Foreshore Lease Application

Ref No:	MS51/8/1340
Applicant:	Monkstown Bay Marina Co. Ltd.
Location:	Monkstown, Cork harbour, Co. Cork
Development:	82 Berth Marina

Monkstown Marina
Typical Demountable Flood Barrier (Access Gate)

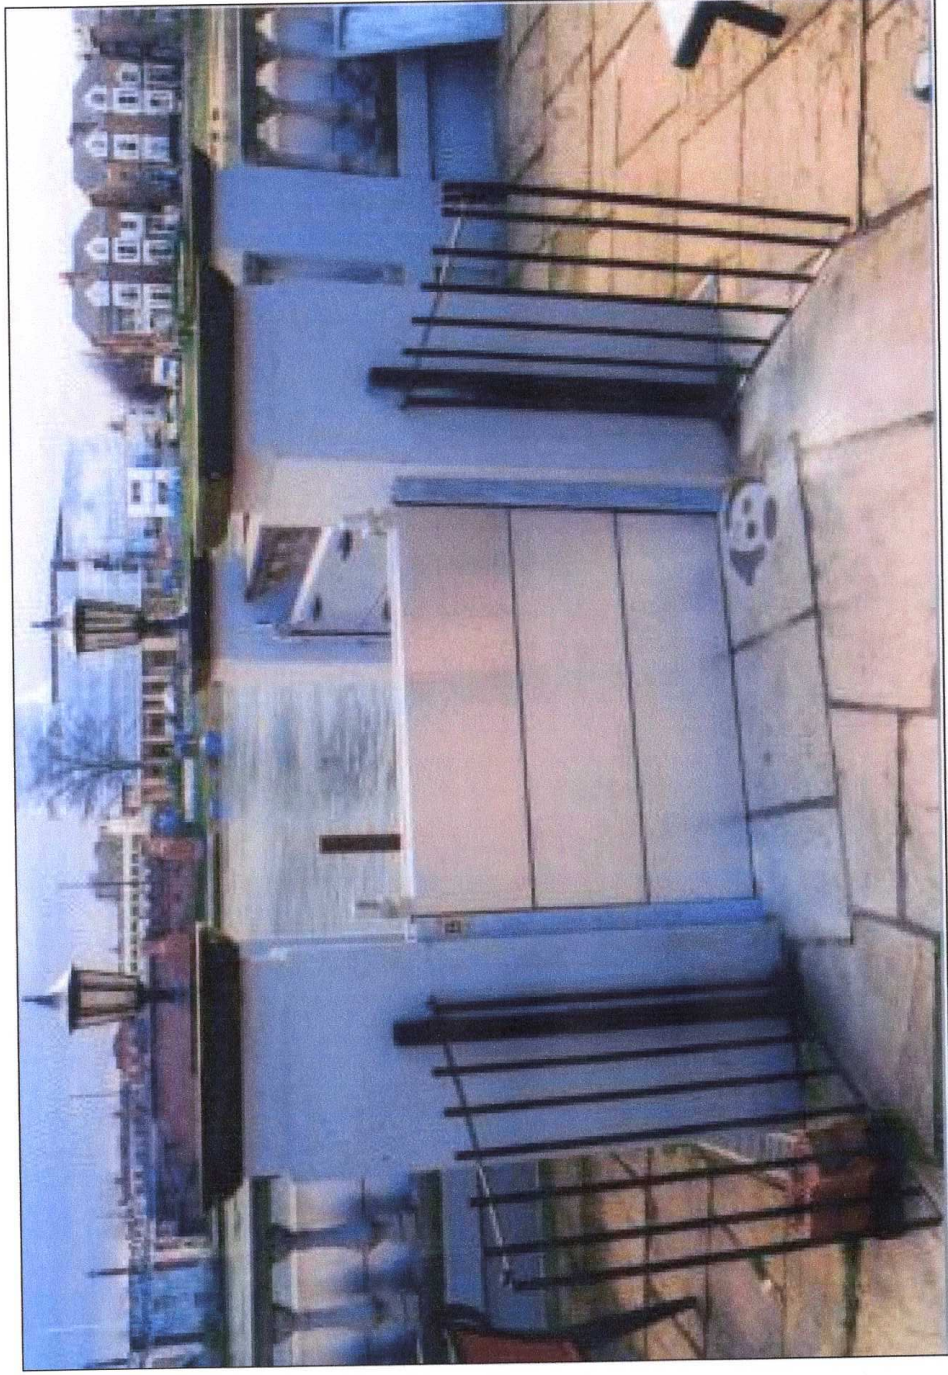
Mr. has expressed concerns that the marina development will result in flooding of the R610 public road, due to the roadside wall being breached.

Monkstown Bay Marina Co. Ltd. are willing to install a demountable "slot in" flood barrier across the entrance if required. This barrier would be installed when flood warnings are forecast by the OPW. A sample image of this type of flood barrier is enclosed for your information.

The proposed level of the access platform and the threshold of the gate where it joins the wall is approximately 200mm above the existing footpath, which is approximately 150mm above the road level and gully cover level. The threshold of the access gate will therefore be approximately 350mm above the road gully level. It is therefore evident that the road will flood via the existing road gullies before the sea level rises to the level of the access platform.

The existing road wall was increased in height in 1970, to stop wave/spray being driven onto the public roadway during storms. The marina will incorporate a floating wave attenuator around its perimeter, which will reduce the height of waves before they reach the wall. The access platform will also assist in reducing the wave height at the location of the proposed access gate.
